Technical Information Bulletin

Subject: SF Return Motor Ass'y Modification **BULLETIN NO.: 144**

To connect existing SF3000 to a GR unit with the new Stripper unit, part number 019-91712-000, (See TIB 141), a small modification is required on the SF Return Motor Assembly.

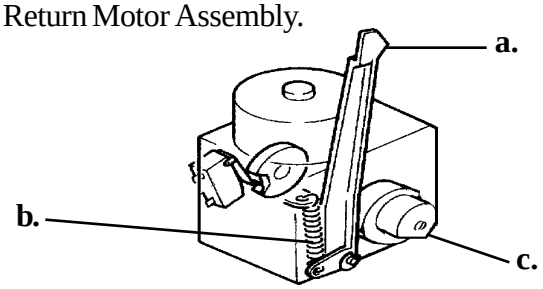
1. Remove the (a) Sheet Return Bar, (b) Return Spring, and (c) Return Cam.

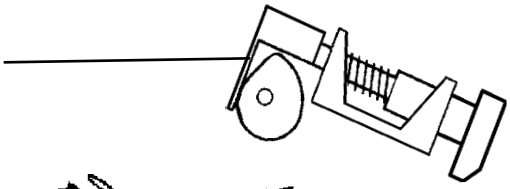
4. When installing the new type SF Return Motor Assembly, grease the actuator plate of the Stripper Unit.

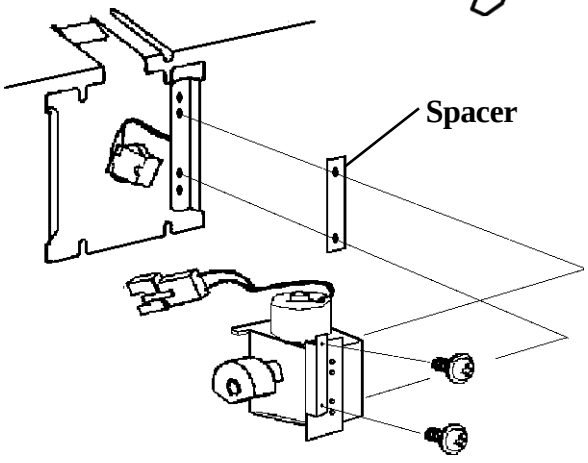
5. Join the connectors and install the SF Return Motor Assembly, using the new Spacer.
